A New Branch Bank for: Citizens Progressive Bank 5031 Cypress Street (Hwy) 80 West Monroe, Louisiana 71291

Addendum No. 1

October 31, 2024

## TYPICAL CONCRETE PAVEMENT JOINTS

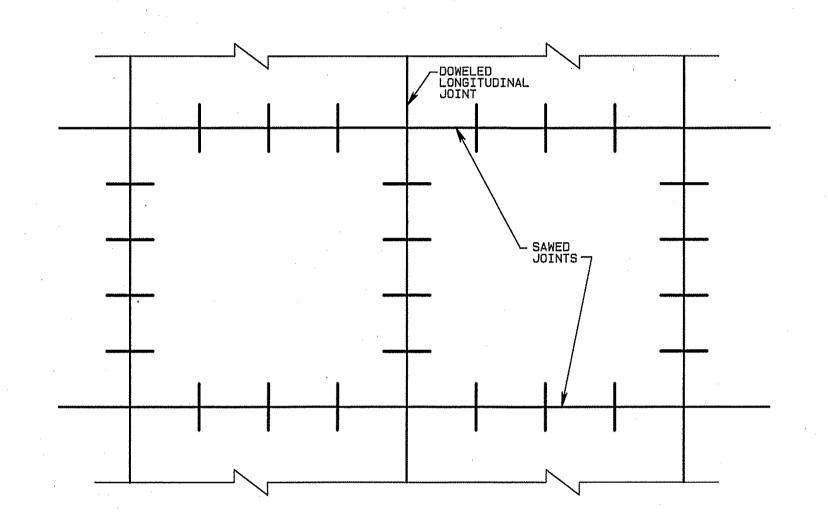
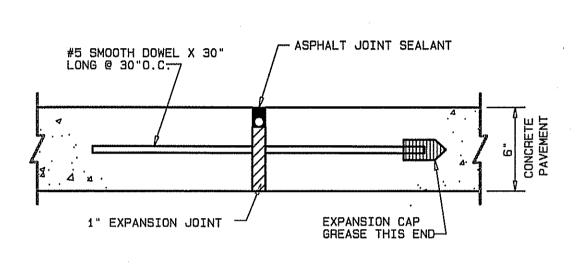
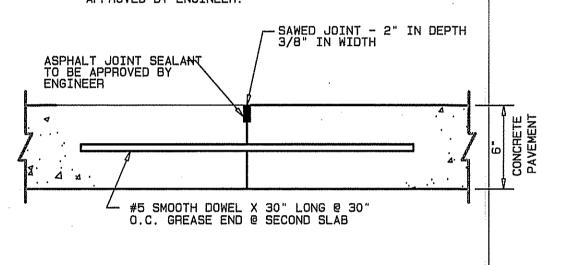
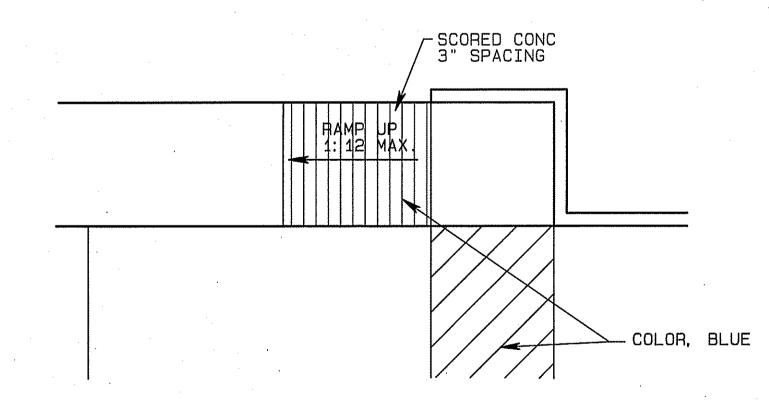
- 1. Please find attached a joint layout plan and concrete details.
- 2. Provide an allowance in the base bid of \$5000 for mantle and wall fireplace.
- 3. Provide 6' high painted treated wood fence around generator and transformer. Use aluminum 4" post with treated (2) 2x4 horizontal bracing between post for nailing 5/8" x 5 1/2" x 6' tall wood pickets. Mount post in 12" round concrete, 14" deep.
- 4. There will not be a trash dumpster area. Relocate the electrical transformer to the previous area of the trash dumpster.
- 5. Landscaping and Irrigation is provided by owner. The GC will coordinate with the subcontractor.
- 6. The drive-thru window is provided and installed by the owner.

SP1.01r1

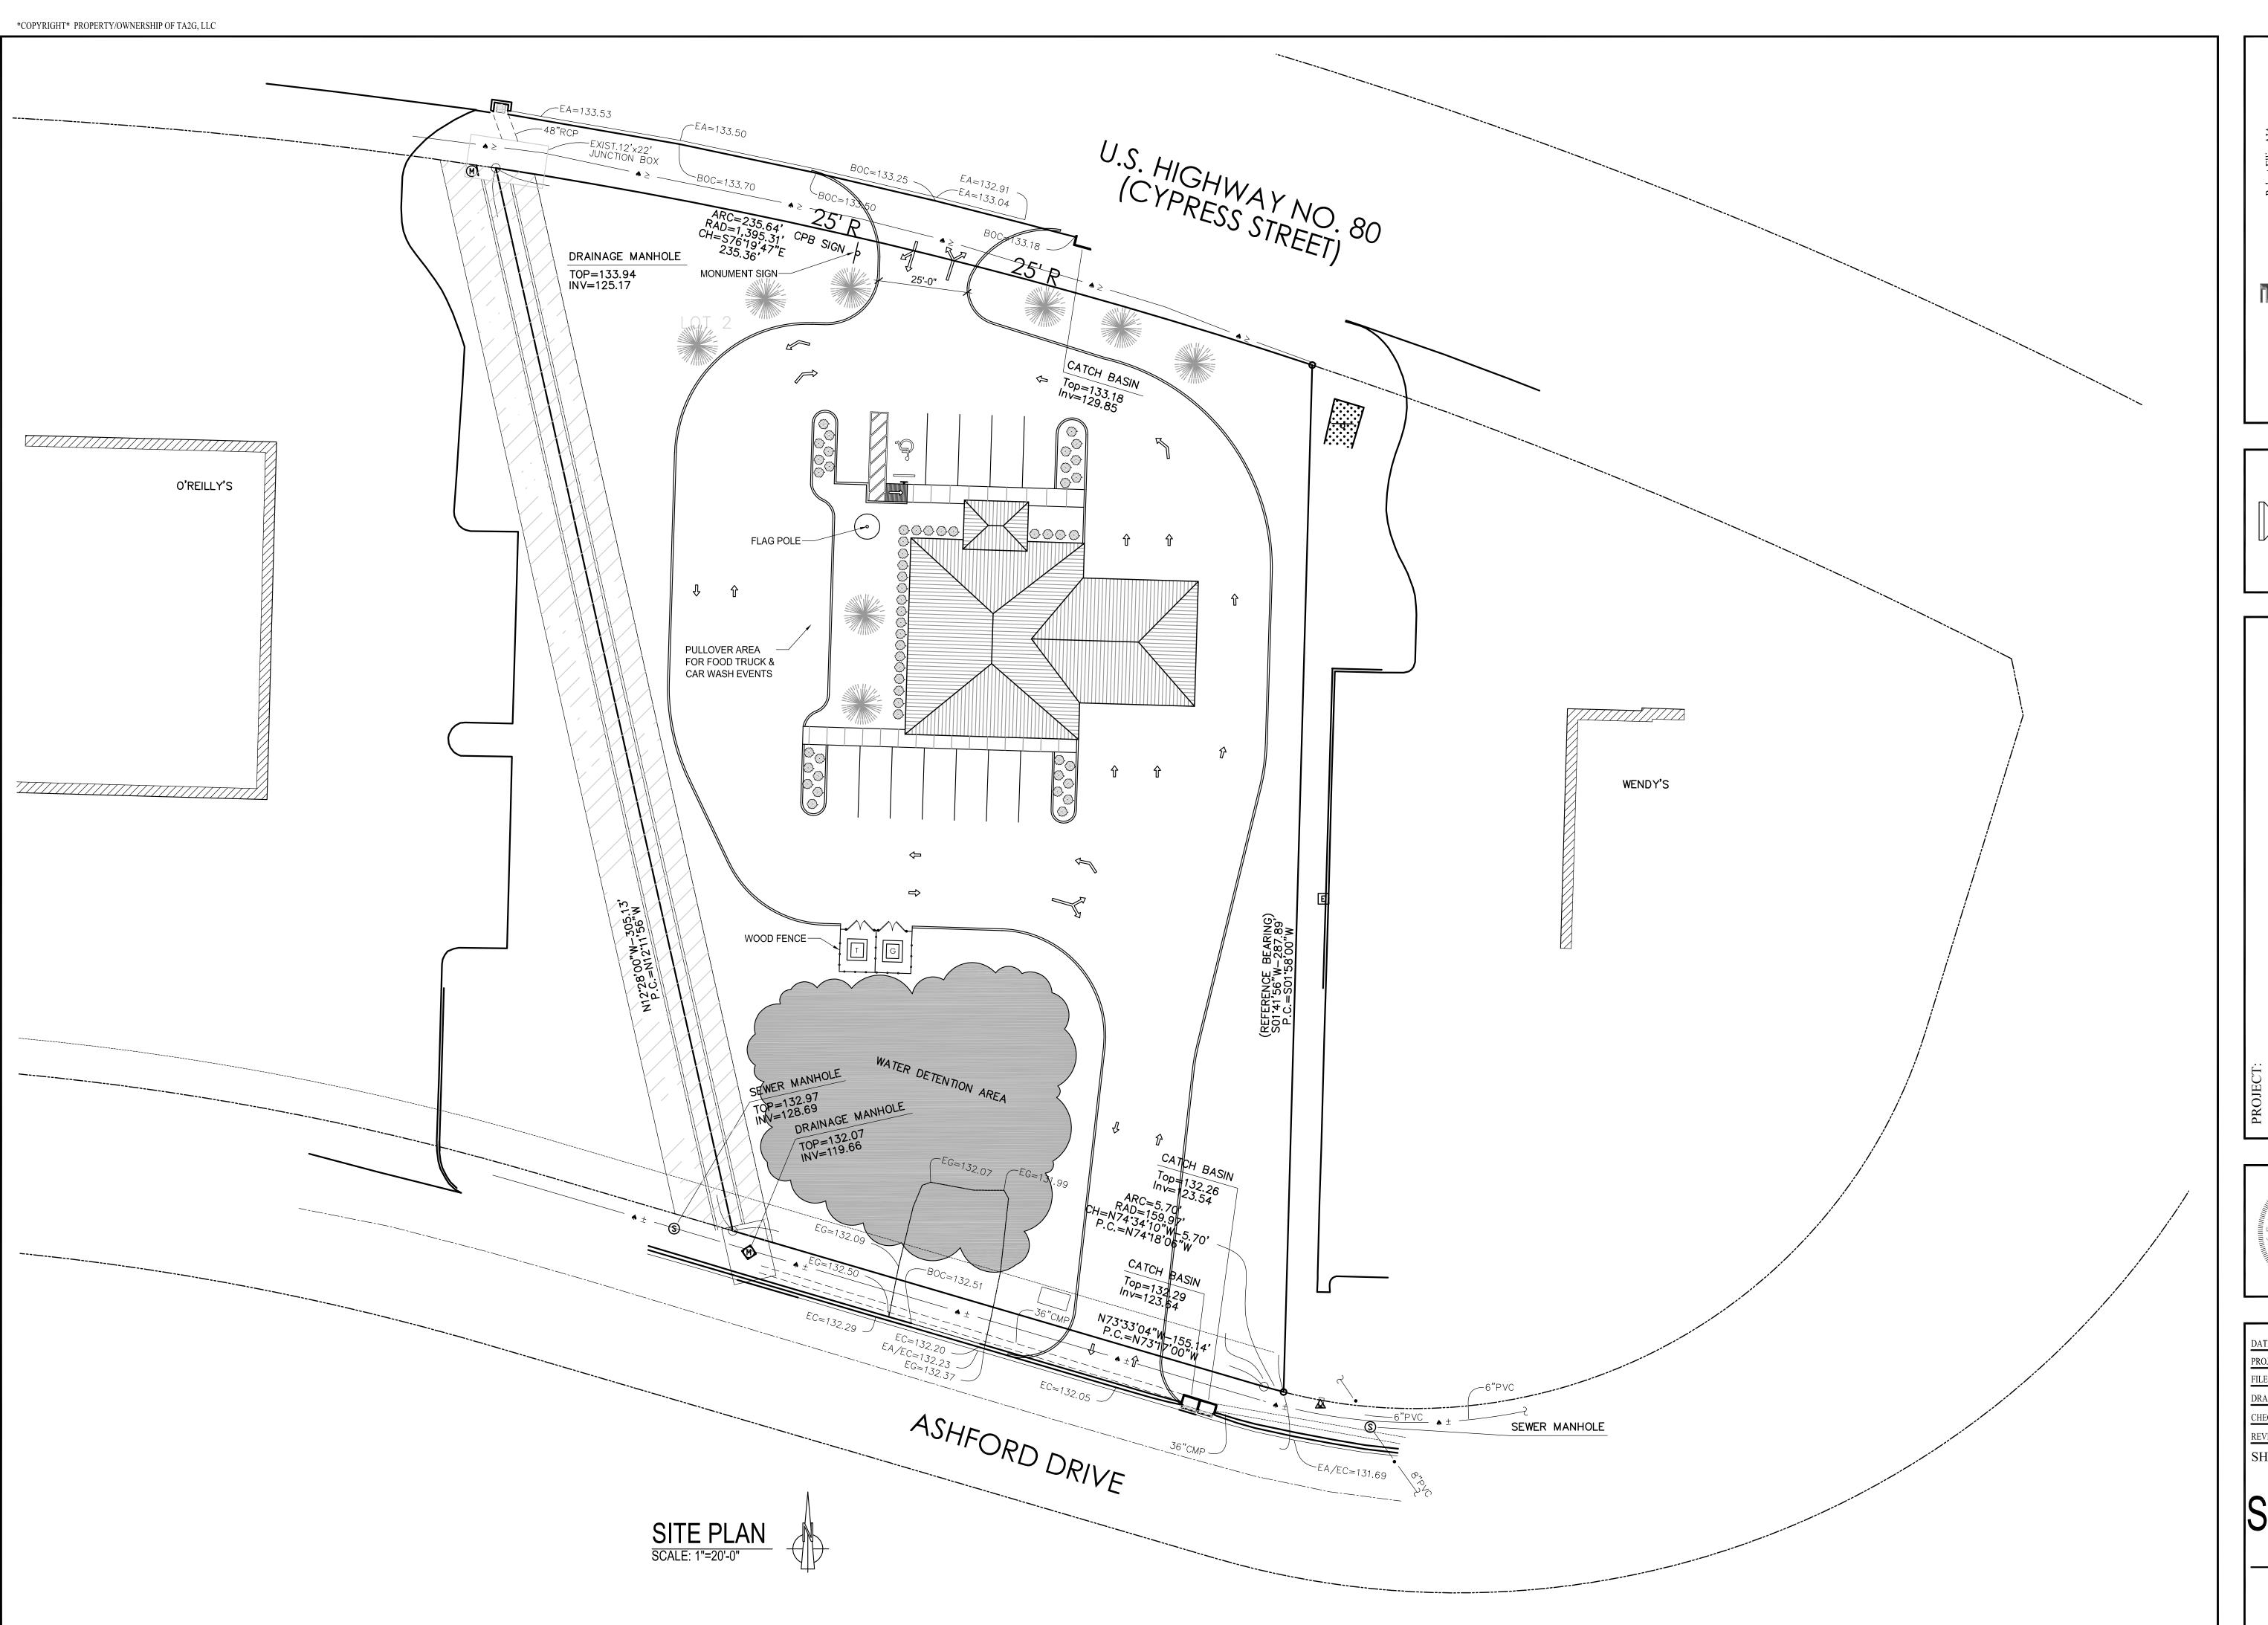
- 10. Building plaque is required per specifications and will be located by owner/architect.
- 11. See revised site plan for location of flagpole.
- 12. Provide 3 lights for flagpole. Use 1 ¼" conduit to flagpole lights from A-67 circuit, E7 outlet. Provide Lithonia DSXF1LED-P1-40K-MSP-MVOLT-THK-DDBXD/PSSA, 2600 lumens, 4000k color with ½" thread knuckle pipe, 7" stanchion mount 120" apart around flagpole. Aim to maximize lighting.

# ISLAND DETAIL / SECTION NOT TO SCALE

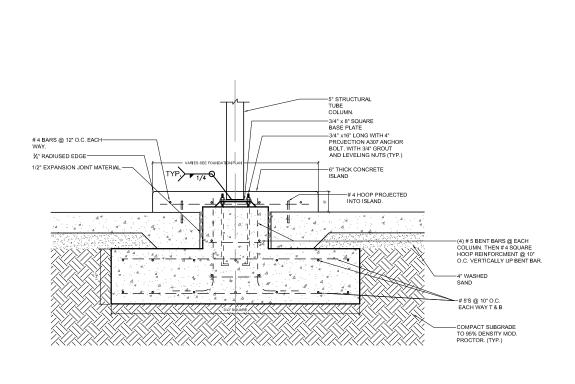
- 22. Beams at front entrance are 8" x 12".
- 23. Provide 5' x 5' x 5" concrete house pad with 6x6x6 mesh with 3000 psi concrete under all hvac units.
- 24. See attached raised curb island details for drive-thru.
